Service Bulletin No. 407

MODEL	D Series	TYPE	Field Change Program	SECTION/GROUP	12-Suspension	DATE	May 7, 2014
SUBJECT	GABRIEL SHOCK ABSORBER POLYURETHANE BUSHING						
CONDITIONS

Figure 2.

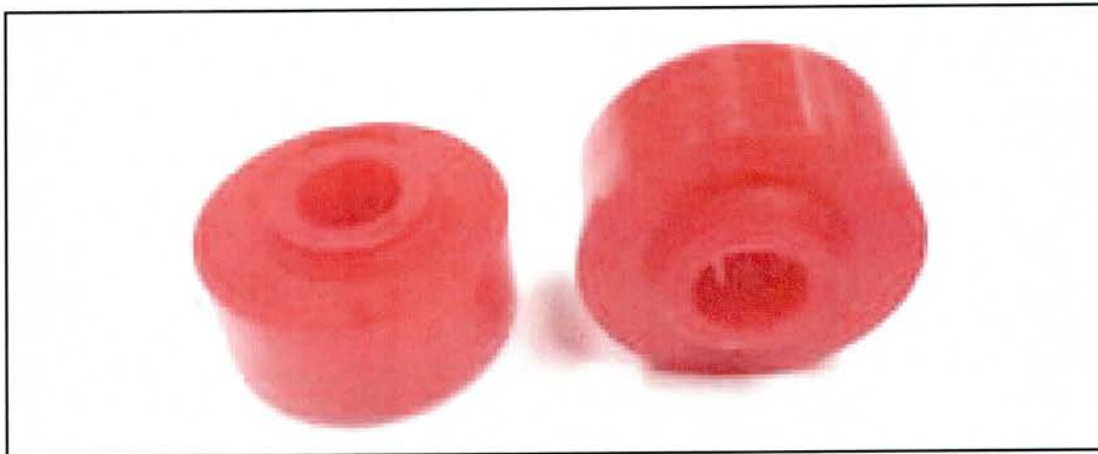
6. Remove and retain the nut from the lower location (stud end) of the drive axle shock absorber.
7. Compress the shock absorber upwards.
8. Remove and discard the existing lock nut, washers and red polyurethane bushing from the lower location (stud end) of the drive axle shock absorber (refer to Figure 2).

12. Unfasten and remove the hex nut, retaining washers and the existing red polyurethane bushing from both ends (upper and lower stud end locations) of the shock absorber. Discard the existing lock nut, washers and red polyurethane bushing (refer to Figure 2).
13. Orient and install the new bushings, p/n 12-05-1320.
14. Re-install the shock absorber with new washers, p/n 12J-3-104 and new lock nut, p/n 19-3-153.
15. Tighten the lock nut until compressed bushing height falls between the range 0.649-0.669 inch / 16.50-17.00mm. (refer to Figure 3).

9. Orient and install the new bushings, p/n 12-05-1320.
10. Install the new washers, p/n 12J-3-104, and lock nut, p/n 19-3-153.
11. Tighten the lock nut until compressed bushing height falls between the range 0.649-0.669 inch / 16.50-17.00mm. (refer to Figure 3).
